Project Name: Home2 Suites
Project Address: 251 NE Alura Way, Lee's Summit, MO 64086
Plan Number: PL2024097

This letter is in response to the Commercial Final Development Plan Applicant's Letter architectural comments dated April 24, 2024. The plans have been revised to address the referenced comments. Our responses are below, **IN BOLD**, and follow the order as shown in the review comments.

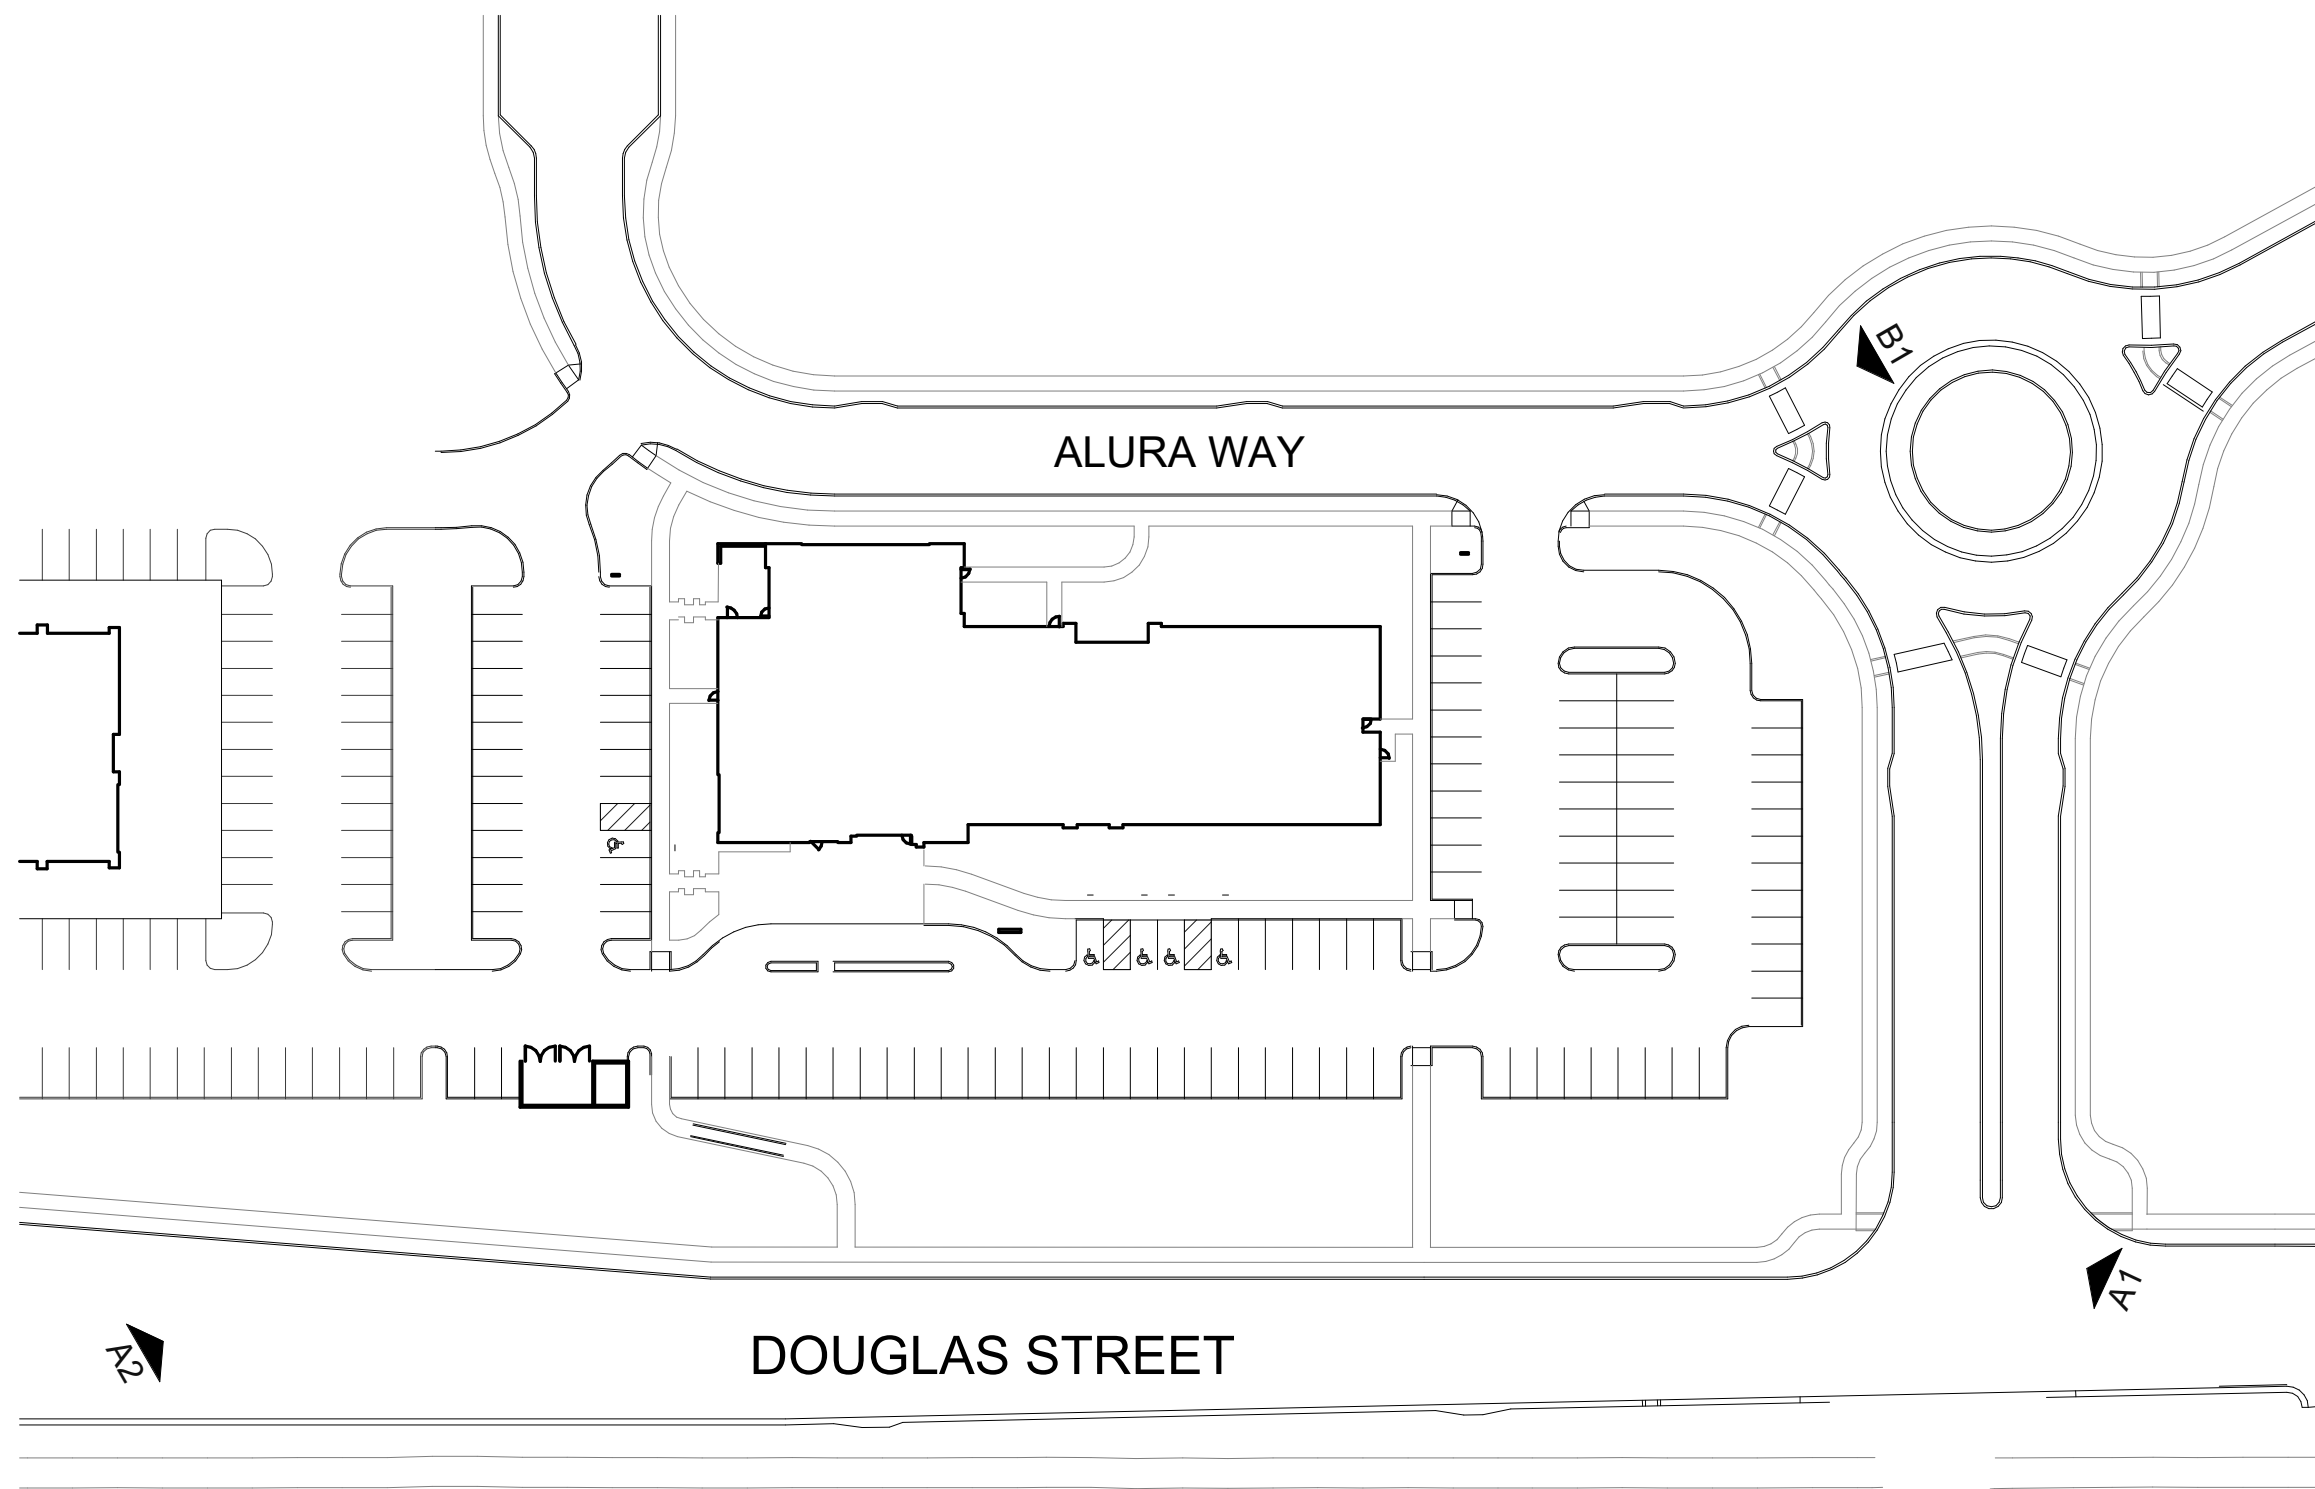
4. MECHANICAL SCREENING. Dash in the RTUs on the architectural building elevations (Sheets A-202 and A-203) to verify compliance with the requirement that all RTUs are fully screened from view on all sides by the use of parapet walls of a height at least equal to the units being screened. Take into account the added height from the curbs on which the RTUs will sit.

Per discussions with Hector Soto on Friday May 10, parapets do not necessarily have to match the height of the rooftop mechanical equipment if it can be demonstrated through the use of sight line studies that the roof mounted mechanical equipment is not visible from the public right-of-way, most importantly the equipment is to be screened from view when along Colbern and Douglas.

Per the exhibit on sheet A-204, all roof mounted mechanical equipment on the 4-story roof is screened from view without the need of parapet revision.

The mechanical equipment on the west side of the building on the 1-story roof is naturally screened from Colbern and Douglas given the building geometry, however, curb mounted mechanical screening is being proposed to screen that equipment from Alura Way and the adjacent hotel unit windows.
